## **STAFF REPORT**

**TO:** Planning Commission  
**FROM:** Sophia Jensen, City Planner  
**AGENDA ITEM:** **Variance Request – 8286 Hidden Bay Court**

Jeff and Judy Otto (Applicants) submitted a variance application for three deviations from the City's Shoreland Management Overlay District Code Section 105.12.1260 Table 17-3. The three requests are: 1) an increase in impervious surface for unsewered shoreland lots 2) A reduced ordinary high water level setbacks for a new home 3) A reduced ordinary high water level setback for a new septic system. These requests are for the property located at 8286 Hidden Bay Court North (Subject Property).

**PROPOSED SITE PLAN  
IMPERVIOUS SURFACE CALCULATIONS**

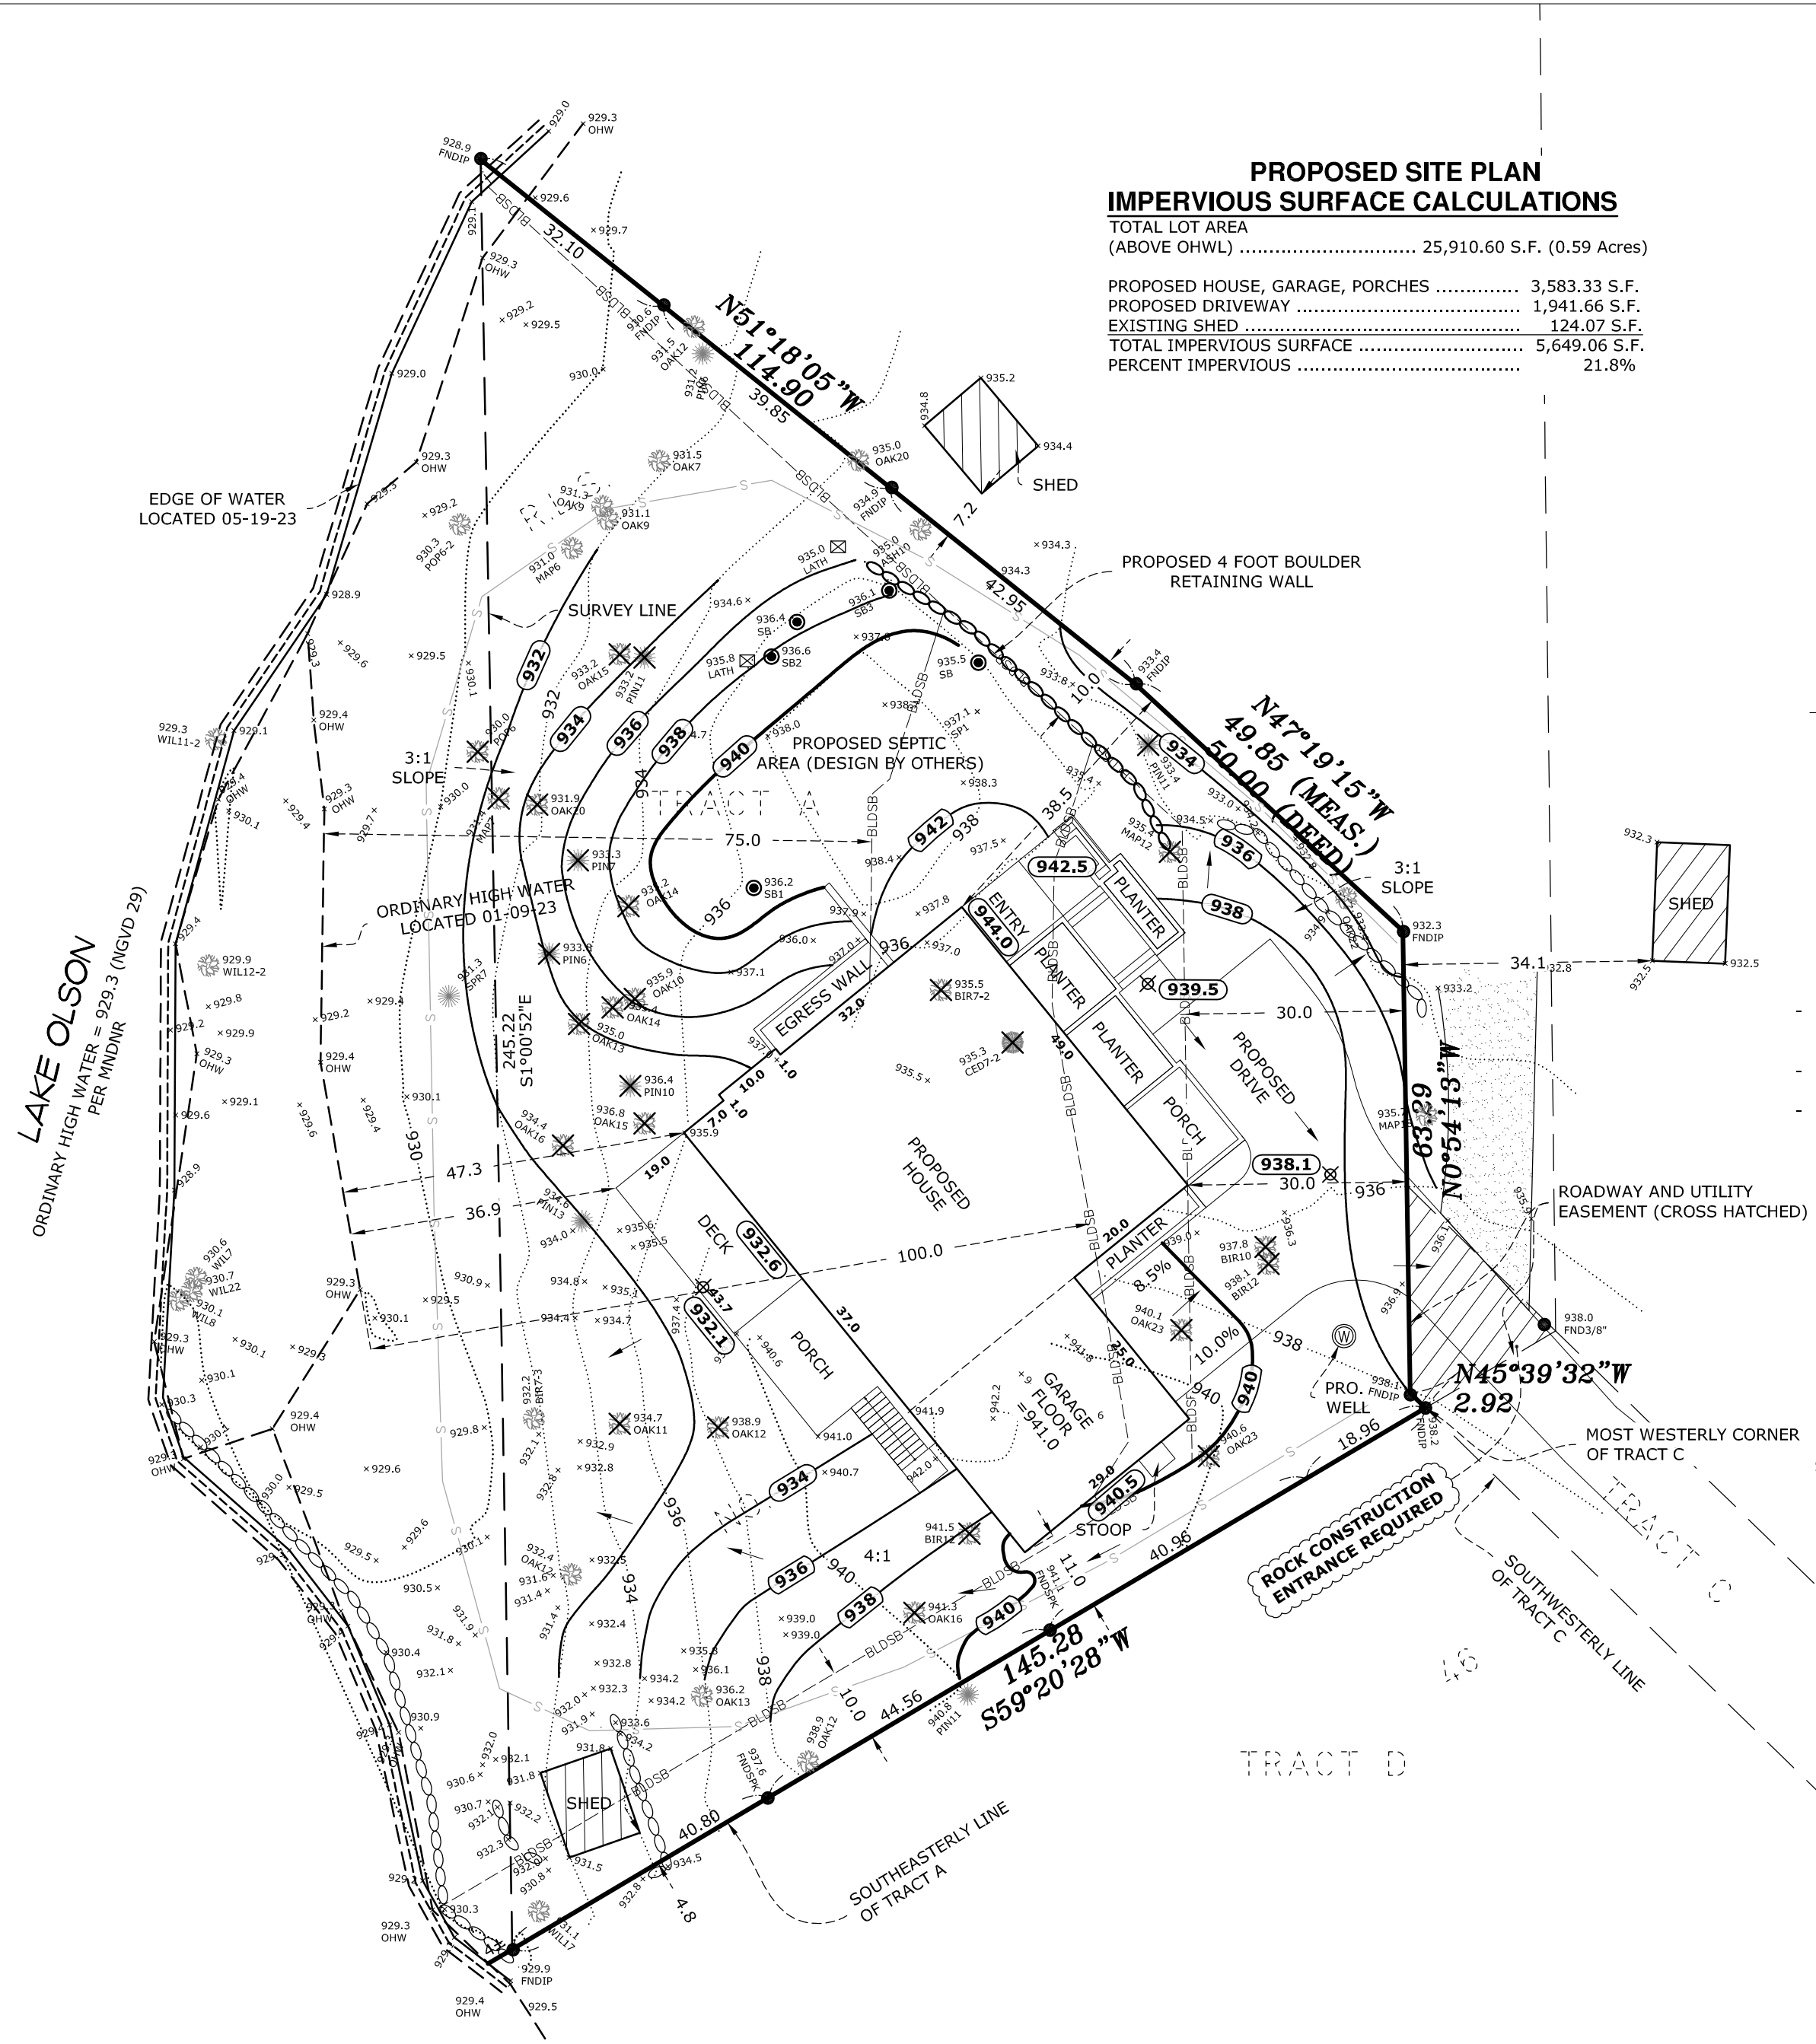
***IMPERVIOUS SURFACE FINDINGS:*** *The applicant argues that the existing lot is too small to construct a new home and driveway that meets their desire to age-in-place and meet impervious surface requirements. Staff finds that the existing home/driveway could be remodeled or refurbished without the need for a variance since it is a legal nonconformity. Otherwise, the lot could fit a smaller home and driveway within impervious surface requirements. The discrepancy here is that the applicants are proposing a new larger home and driveway than code dictates, not that a home on this lot is not possible. **Practical Difficulties are not met.***

**IMPERVIOUS SURFACE FINDINGS:** The applicant argues that they need the main level garage and hammerhead driveway exactly as they proposed for safe access which would cause the impervious surface to increase. Staff finds that the reasoning for the garage and hammerhead driveway insufficient; the residence is at the end of a road where ample or fast moving traffic does not appear to be an impending safety concern. The applicant has the opportunity to refurbish the existing home, garage, and driveway footprint without the need for a variance. By completely redesigning the garage and driveway the applicant is creating the plight which they are requesting flexibility from. **Unique Circumstances are not met.**

**Variance 3** – Increase in impervious surface for unsewered shoreland lots. The proposed re-landscaping on the NW side of the property creates a slope going toward the neighboring property which is also slightly higher at that point, forming a channel that I presume will funnel any run off right into the lake. Based on the drawing, it appears that area will be all grass, which will require maintenance that will almost certainly cause nutrients to flow freely into the lake. The proposed removal of many established trees is another factor in more run off to the lake.

The first concern has to do with the elevation change needed to build up what currently is their basement garage into a first floor entrance. We believe that this elevated and sloped road surface would magnify the amount of rainwater and runoff that naturally occurs today into the back NW part of our property, especially if the road surface is impervious. Today there is an area that collects with water during heavy rains but it drains after a reasonable time. We believe this could become a much bigger issue if the current plan is allowed to proceed.

Figure A | Proposed Architectural Site Plan

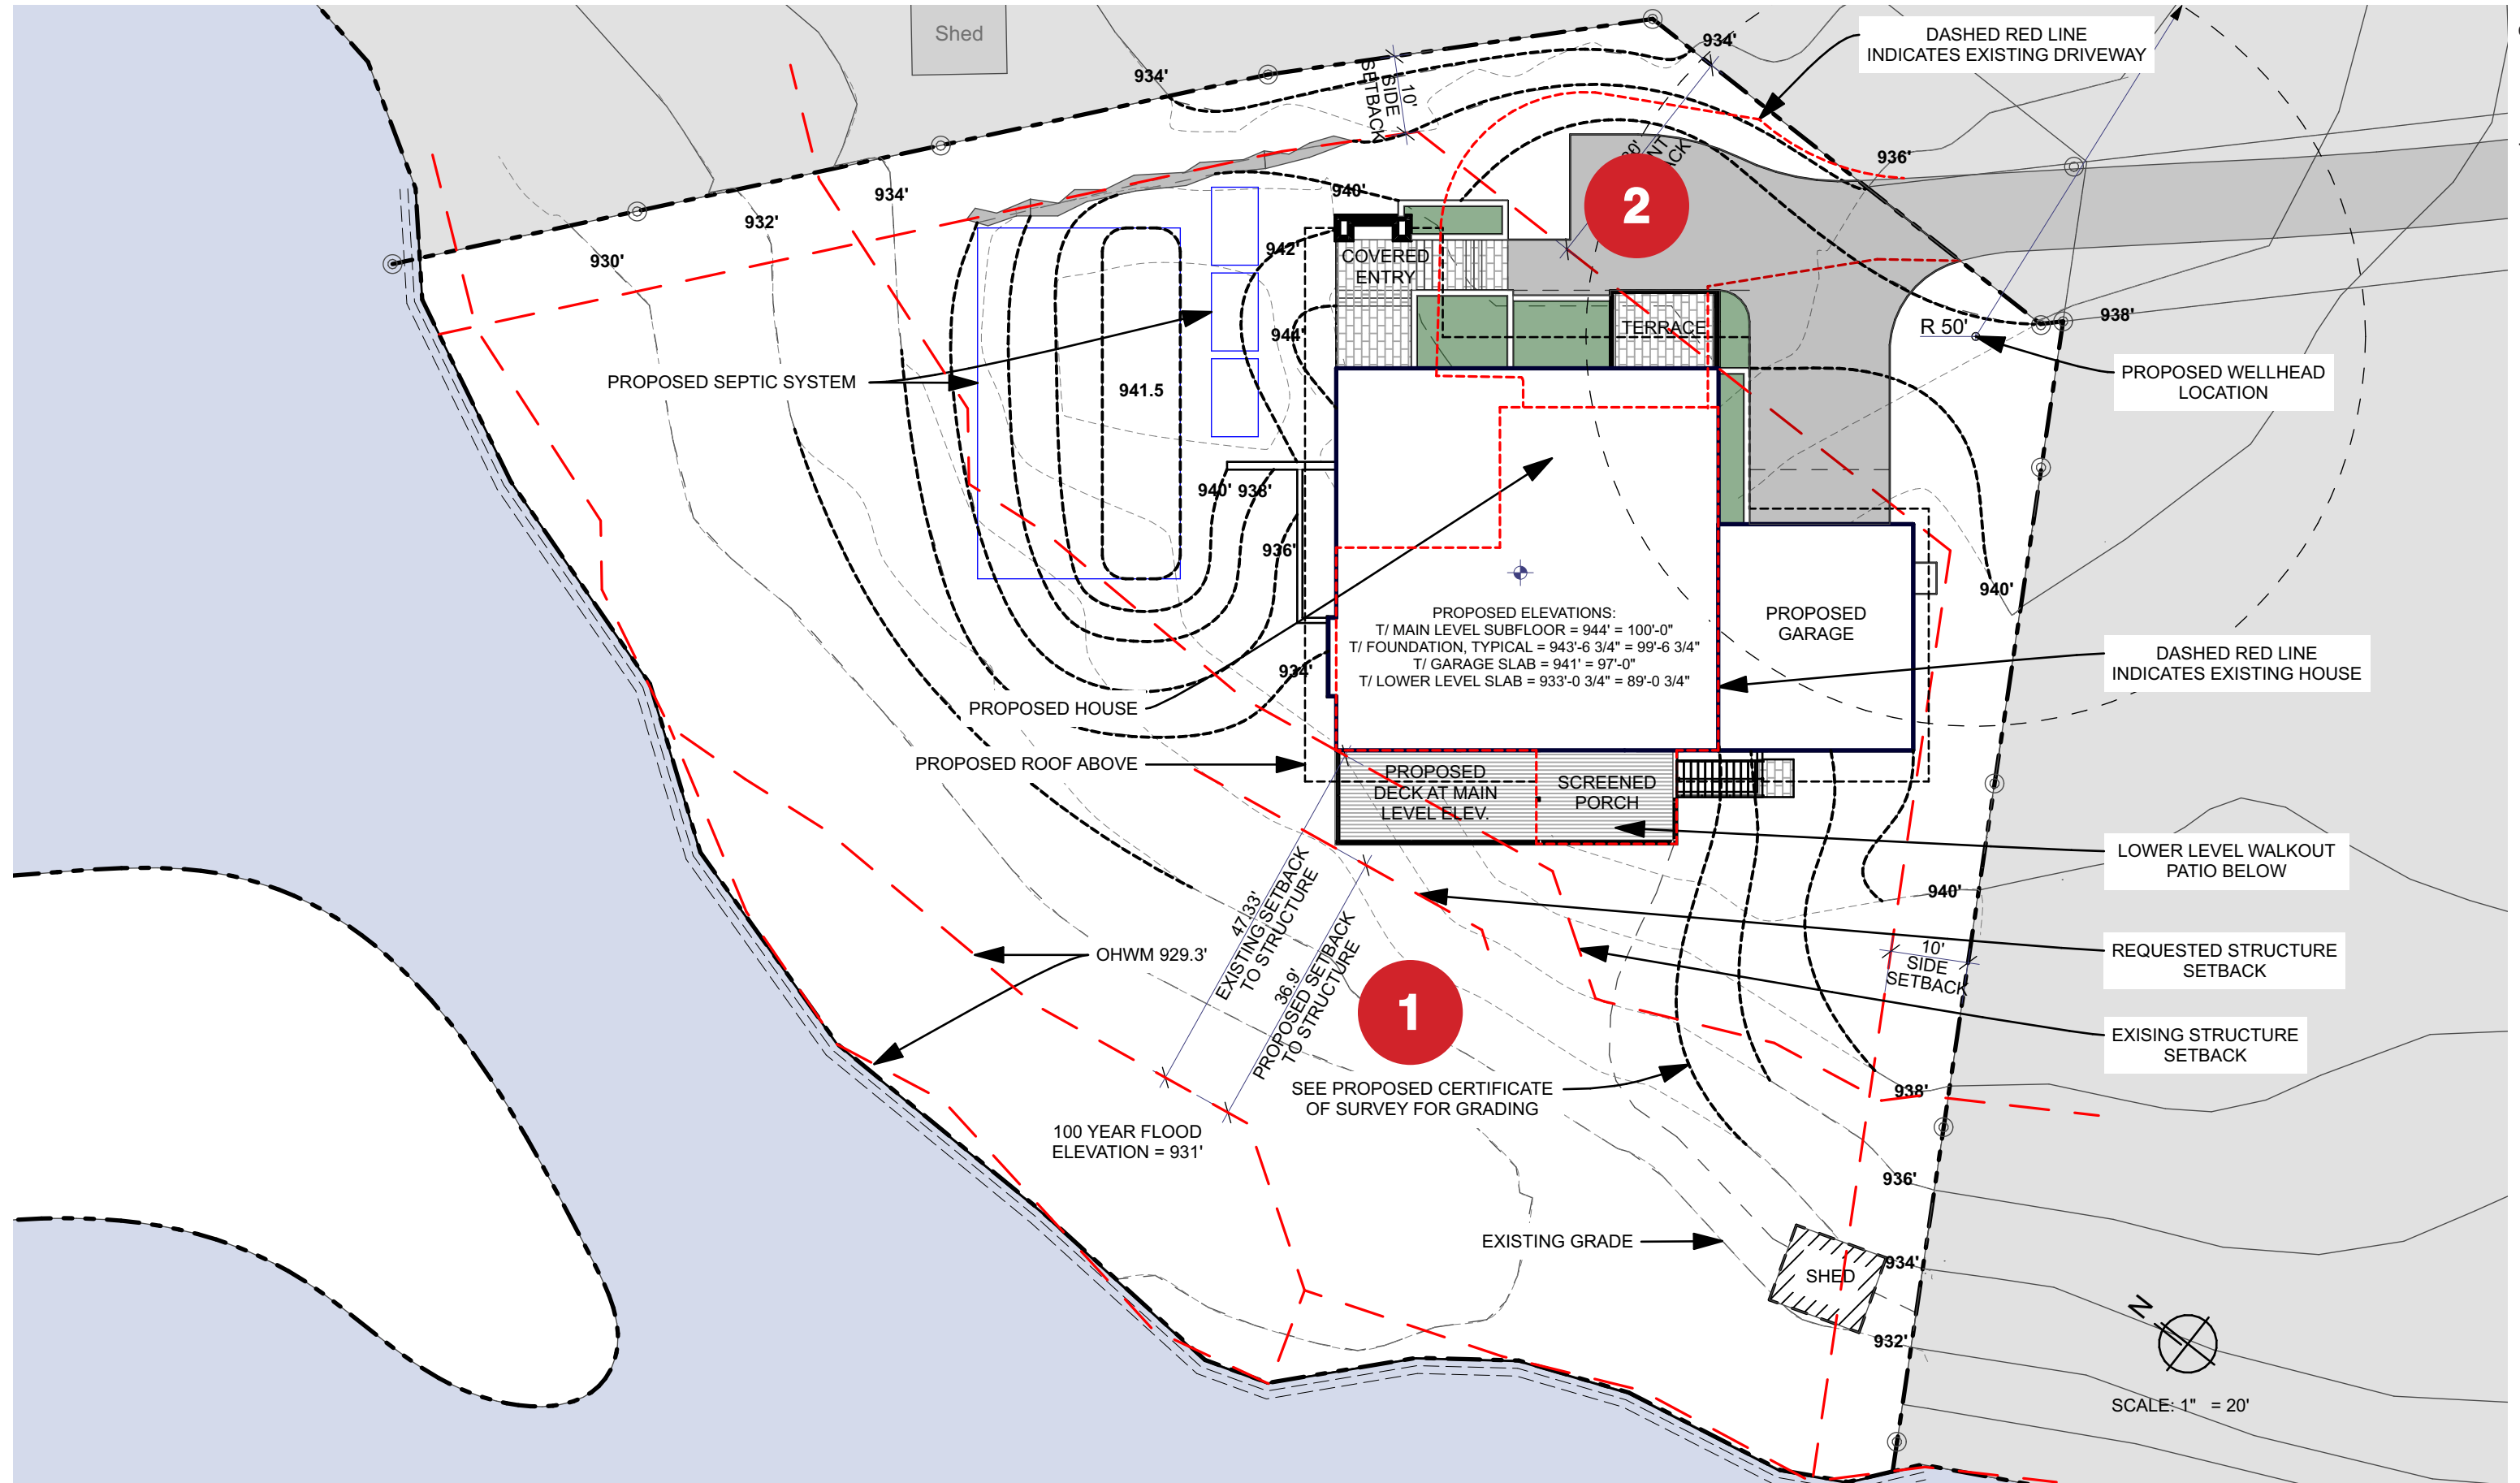
**REDUCED STRUCTURE SETBACK FINDINGS:** While a single family home is consistent with the zoning district. Staff finds that the complete demolition and reconstruction of a larger home and desire for a deck when an existing legal nonconforming home is already on site does not meet the practical difficulties requirement. **Practical Difficulties are not met.**

**REDUCED STRUCTURE SETBACK FINDINGS:** The applicant argues that the setbacks are excessively large on this property, and a portion of the property is below the ordinary high water level, leaving a small buildable area for a new home. Staff finds that these requirements are in place to protect the waterbody and prevent damage to structures. Many properties have land that fluctuates over or under the ordinary high water level based on environmental factors, these areas may be subject to flooding or act as a wetland buffer. The ordinary high water level setbacks apply to all properties on the designated water body and not unique to this lot. Given that the applicant is proposing to demolish the existing legal nonconforming home and is then requesting flexibility to move the structure closer they are creating the plight they are requesting flexibility from. **Unique Circumstances are not met.**

- The application proposes removal of numerous trees located between the principal structure and Lake Olson. These trees provide important shoreland habitat and provide screening of structures as viewed from the water. If the City determines that the variance criteria have been met, DNR recommends the city require a tree replacement plan as a condition of approval.
- The proposed increase of impervious surface from existing conditions, 4,754 SF (18.3%) to proposed conditions, 5,649 SF (21.8%), should be carefully scrutinized. The application, for example, does not explain why the driveway area needs to be expanded from the existing condition of 1775 SF to 1941 SF to provide for adequate ingress/egress. We recommend requiring the applicant to maintain the existing footprint of the driveway.
